## **L & H PLACE SUBDIVISION**

Engineering Comments: The following comments should be addressed prior to submitting the FINAL PLAT for acceptance and signature by the City Engineer:

APPLICATION NUMBER		12		DATE		March 5, 2015									
	R-A		R-3		T-B		B-2		B-5		MUN		SD-WH		T5.1
	R-1		R-B		B-1		B-3		I-1		OPEN		T3		T5.2
	R-2		H-B		LB-2		B-4		I-2		SD		T4		T6

# DETAIL SITE PLAN

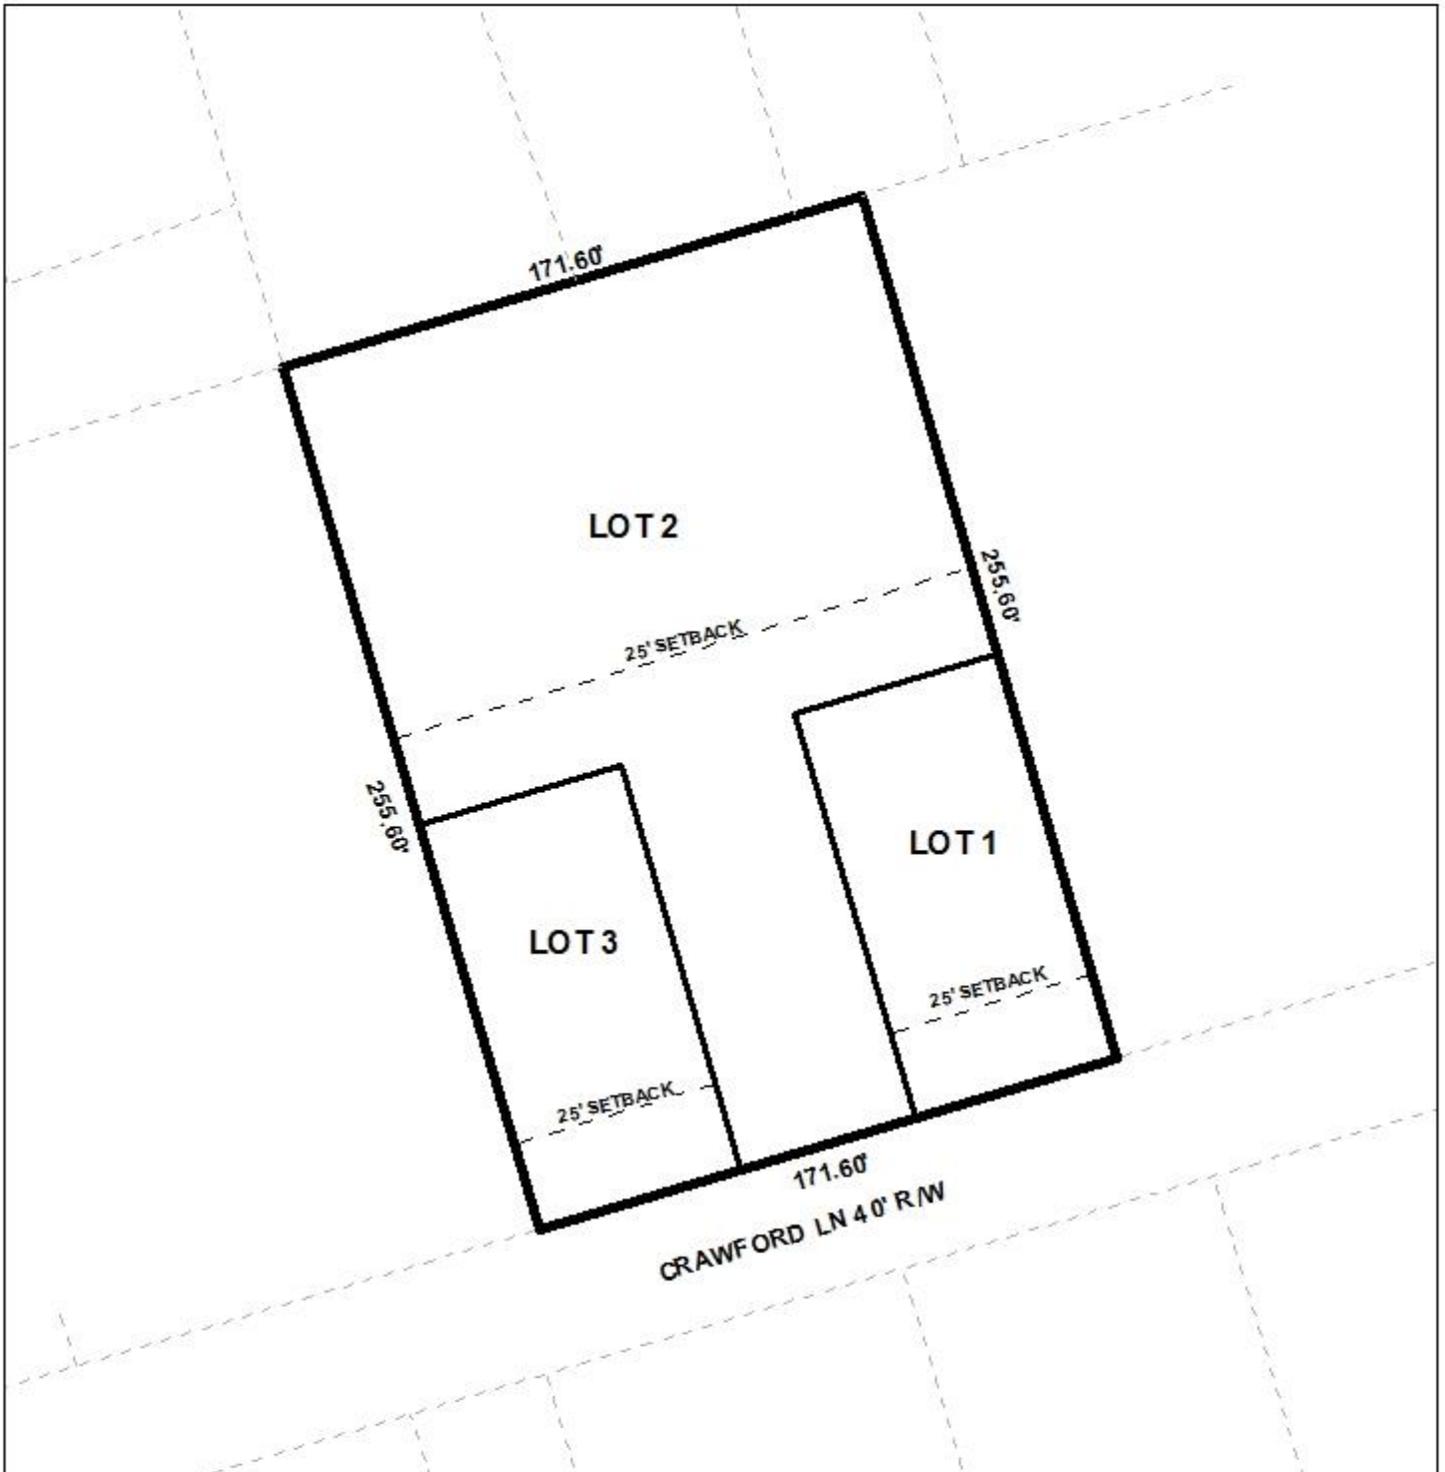
- E. Add/Correct the spelling of the street name (HOLT RD) in the written legal description.
- F. Provide and label the monument set or found at each subdivision corner.

The site fronts Crawford Lane, a minor street with a current substandard 40' right-of-way; therefore, dedication would be required to provide 25' from the centerline of Crawford Lane. This would result in the two proposed front lots losing 5' of depth and lessening the sizes to 6,900 square feet, below the minimum required 7,200 square feet. However, the site does provide sufficient area to reduce the size of the large rear lot and provide compliant area for the two front lots after dedication. As a means of access management, each lot should be limited to one curb cut to Crawford Lane, with the size, design and location to be approved by Traffic Engineering and conform to AASHTO standards.

As proposed, the Subdivision would create a flag lot which is generally not allowed by Section V.D.1. of the Subdivision Regulations, except in those locations where varied or irregularly-shaped lot designs are common and the informality of design is consistent with other lots in the vicinity; or, where unusual circumstances such as an odd shaped lot exists; or, separate disparate uses exist on a single lot; or, where there are natural or pre-existing man-made barriers which may cause an undue hardship on the land owner; or in the case of a family division. None of those criteria have been presented in this instance to justify the three lots as proposed. The Regulations also require that requests for panhandle or flag lots shall be accompanied by evidence showing that each panhandle or flag lot is necessary to allow the site owner reasonable use of the site or to alleviate a situation that would otherwise cause extreme hardship. Again, such evidence has not been presented. The narrative indicates that the Subdivision is primarily intended to create the two smaller lots for rental housing purposes. It should be noted that the adjacent apartment units noted were approved via a Variance in 1967.

There are no other flag lots within the immediate vicinity to justify the Subdivision as proposed. However, the site contains enough area to allow a two-lot Subdivision with lots harmonious to the surrounding neighborhood. Therefore, this application should be heldover to the meeting of April 2<sup>nd</sup> to allow the plat to be revised to a two-lot Subdivision.

Based upon the preceding, this application is recommended for holdover to the meeting of April 2<sup>nd</sup> to allow the plat to be revised to a two-lot Subdivision which would be more in harmony with the surrounding neighborhood. Revisions are due by March 16.
